Re: Jackson Park
Section 106 Historic Properties Inventory Report Comments

RE: Response to request for comments on the Historic Properties Inventory (HPI) and Archaeology Reports and preliminary eligibility determinations

Figure 1: Diagram Supporting Revised APE

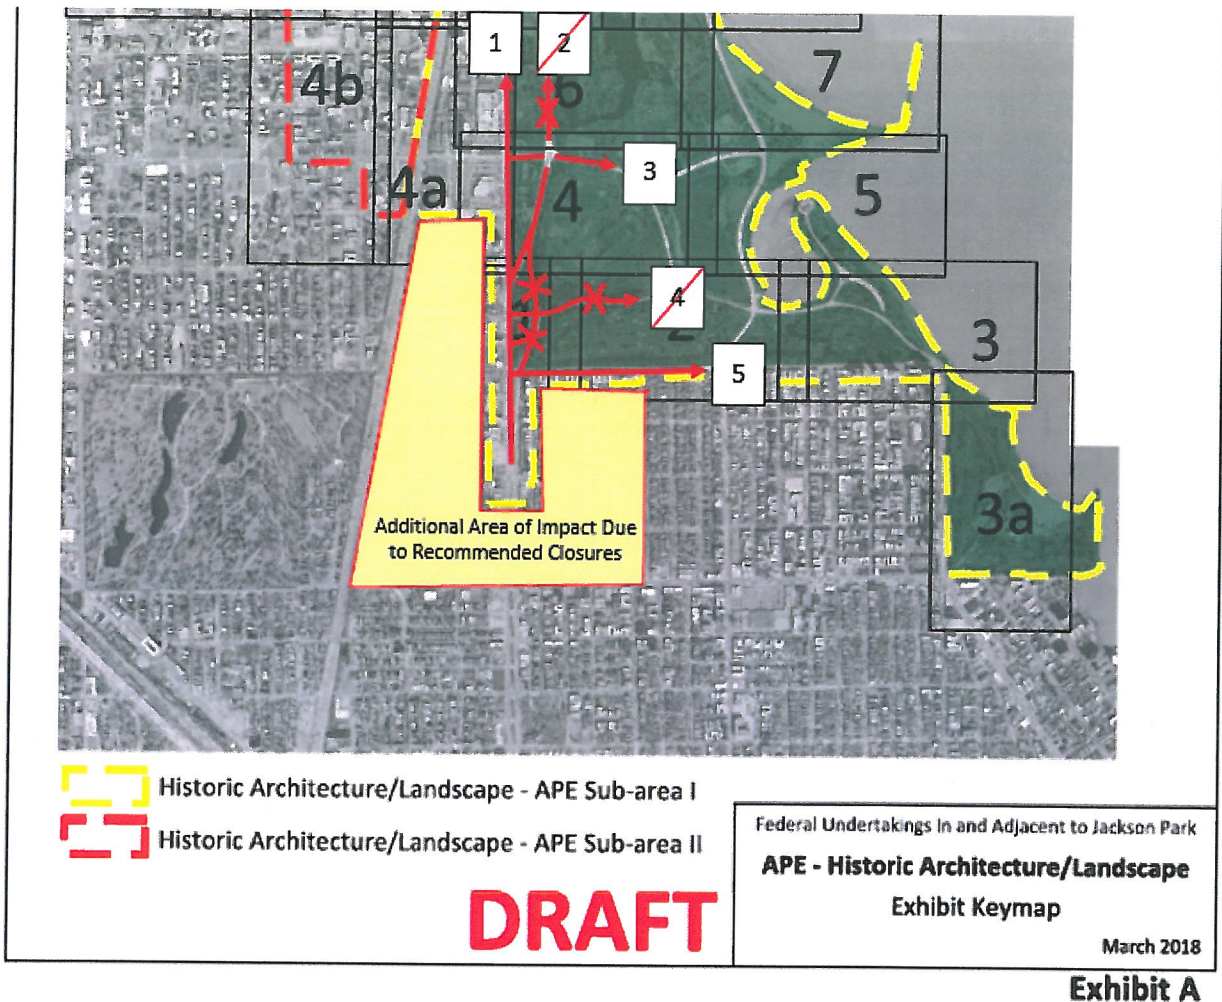
The Section 106 Report states that requests were "made for modifications to the Historic Architecture/Landscape APE. These requests were considered and evaluated based on three criteria: consideration of the development history that could be linked to Jackson Park, the likelihood of direct impacts as a result of potential construction, and the likelihood of indirect visual impact as a result of the construction of the OPC Tower," Section 106 Report, p. ii. Yet, the Historic Properties Identification Report prepared for FHWA and the National Park Service rejected designating Jackson Park Highlands and/or the South Shore Neighborhood as part of the APE. While we agree that the APE does not need to include the full area of both neighborhoods, with the acknowledged impacts, the APE should extend to portions of these neighborhoods. Simply, the range of road alternatives carrying traffic into and out of portions of South Shore are reduced from five to three, due to the proposed closures. Given that the proposed closures, ensuing circulation patterns, and traffic issues will almost certainly impact these neighborhoods, the decision to exclude at least the portion of South Shore as indicated from the APE seems illogical given criteria two highlighted above. Therefore, we recommend that the portion of South Shore bounded north to south between 67th and 71st Streets and east to west between Cregier Avenue and

Stony Island be included as indicated by the diagram below, as these meet the criteria in the Section 106 Report.

Figure 2: Diagram Indicating Missing Information to HPI Report Figure 7

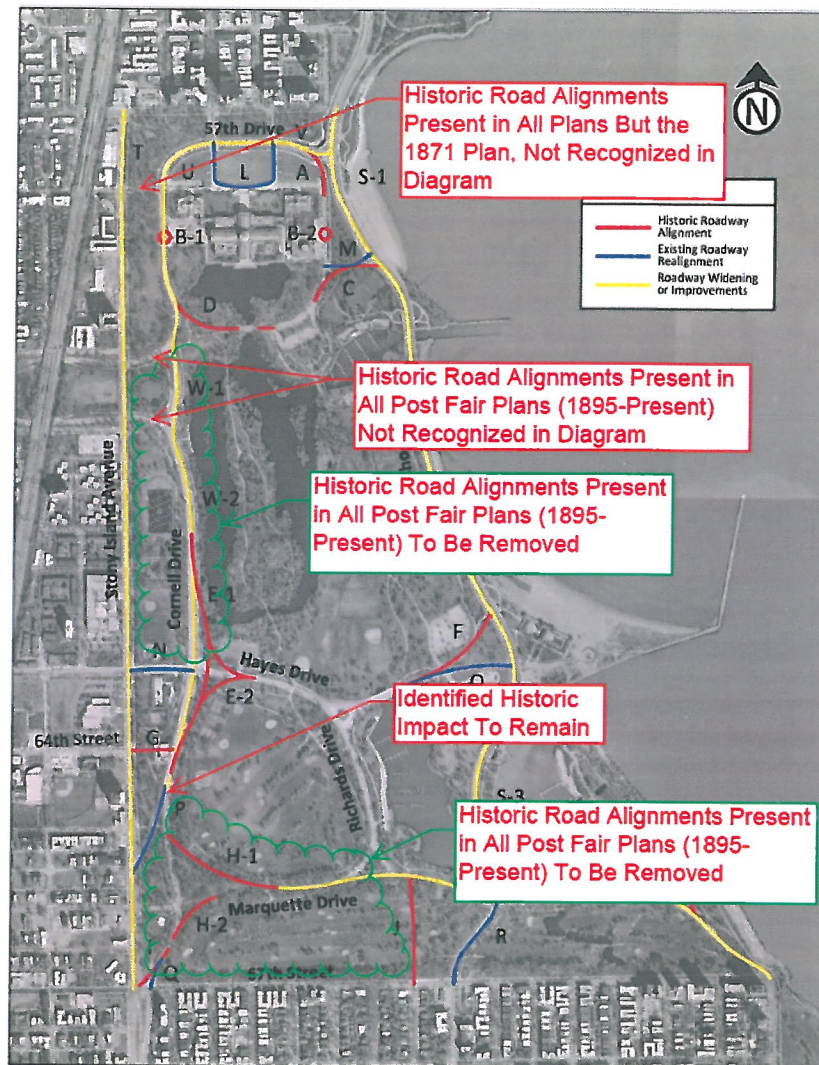
- Landscape Evolution of the Western Perimeter and Circulation, Sections 2.1.2.1 & 2.1.2.2.1: We are concerned that several vital historic elements, such as roads and connections, are not included in the section on circulation as well as the Figure 7 diagram. For example, the connections to 57th Street on the west side of the park, as well as the connections to the Midway

Plaisance have not been indicated in red and should be. As witnessed in Figures 3-6, and Figures 11-14 of the document, these roads are continually present throughout the history of the park plans, except for the 1871 and 1893 plans.

This oversight results in a major omission of the historic road alignment at the terminus of the Midway Plaisance, which alters its intended character and sense of place. The FHWA roadway project proposes to remove the southernmost east bound lane of the Midway where it connects into Jackson Park, removing not only an important and a historic symmetrical component of the plan, but also an important physical connection. It is precisely this connection that serves as a defining feature, for it behaves as both terminus to the Midway, as well as a crucial intersection and arrival point into Jackson Park. In removing this portion of road for ease of accommodating the northerly adjustment of the OPC site, a logical, important, and historically significant pattern of flow, views, and a manner of experiencing the park is lost. Ironically, the report describes this precise area on page 75 as “the area within the Western Perimeter that retains the highest level of integrity. The proposed spatial reorganization will alter the integrity of this important moment as

Figure 3: HPI Report Figure 14, For Reference

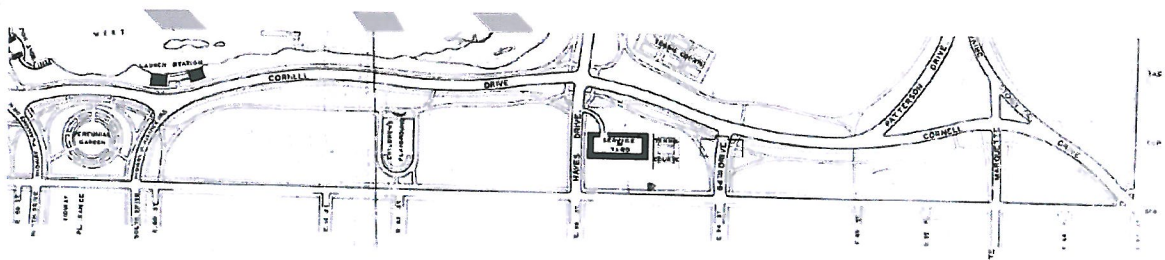
Furthermore, the Section 106 report states that “[t]he southbound lanes of S. Cornell Drive were rerouted across the southwest corner of the park. Other roadways were moderately widened, but generally following their historic alignments. As a result of these projects, the landscape of the Western Perimeter was substantially altered.” This contradiction results in acknowledging and protecting certain Section 106 resources while not protecting other historic features that have the same critical import. There are other examples of this omission. The Section 106 Report proposes the closure of the historic route of Cornell Drive at the southwestern corner of the park, while allowing the spur between Cornell and Stony Island, identified as an impact, to remain. A comparison of Figures 14 and 15 illustrate this contradiction, when juxtaposed to the proposed closures.
